APPLICATION NO.	FILING DATE	FIRST NAMED INVENTOR	ATTORNEY DOCKET NO.	CONFIRMATION NO.
09/920,640	08/03/2001	Steve Mead	12440-02/ejg	6057

Office Action Summary

DETAILED ACTION

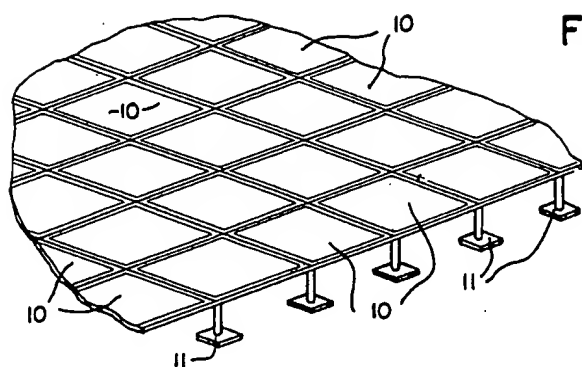
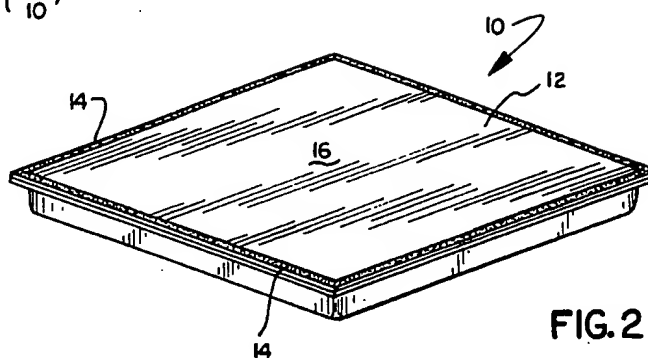
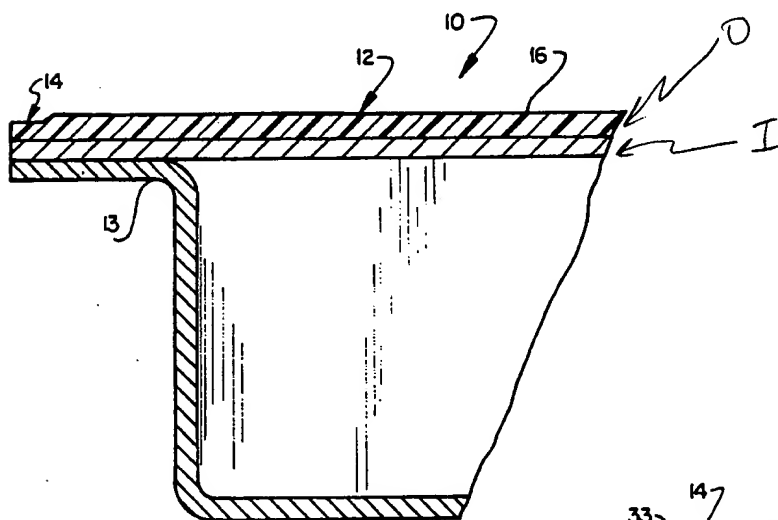
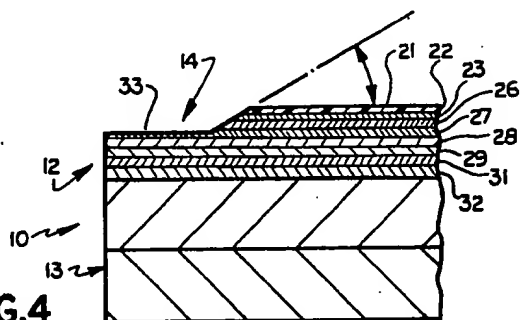
#4,625,491 to GIBSON. GIBSON discloses a floor panel (10) including a base (13) and inner (I)

and outer (O) panels adhesively bonded thereto, column 3, line 19, see the marked-up attachment. The outer panel (O) further includes a border as at (33). Regarding claims 2 and 3, the outer panel (O) includes a decorative surface (23 and 26-29); and the inner panel (I) includes another decorative surface (31,32). In reference to claims 4 and 5, the inner (I) and outer (O) panels both are formed as high-pressure laminates, column 3, line 38. Regarding claim 6, both the inner and outer panels (I,O) include high wear films, column 3, line 36.

#4,625,491 to GIBSON. GIBSON discloses an elevated floor (10) including a base (13) and

inner (I) and outer (O) panels adhesively bonded thereto, column 3, line 19, see the marked-up attachment. The outer panel (O) further includes a border as at (33). GIBSON discloses the basic claimed elevated floor except for the panels are square as opposed to being rectangular. However, it would have been obvious to one having ordinary skill in the art at the time the invention was made that the shape of the panels would be an obvious matter of design choice. Further, rectangles and squares are generally the same except for the length, thus the selection of either would have been within the general skill of a worker in the art. The shape of the panels basically determines the overall external appearance. In reference to claim 8, the inner panel (I) includes a dark surface (31,32) and the outer panel (O) includes a decorative surface (23, 26-29). Regarding claim 9, the outer panel (O) further includes a clear resin film (22). In reference to claim 10, a clear resin film is provided between both the inner (I) and outer (O) panels, column 3, lines 33-35. Regarding claim 11, a plurality of the panels (10) are arranged in abutting edge-to-edge relationship to form an elevated floor, see Figure 1. In reference to claim 12, the method of forming the base panel is not germane to the issue of patentability of the device itself. Thus, the fact that the base panel is stamped to be formed has not been given patentable weight. Further, the base panel 913) of GIBSON is made from sheet steel, column 2, lines 47-48.
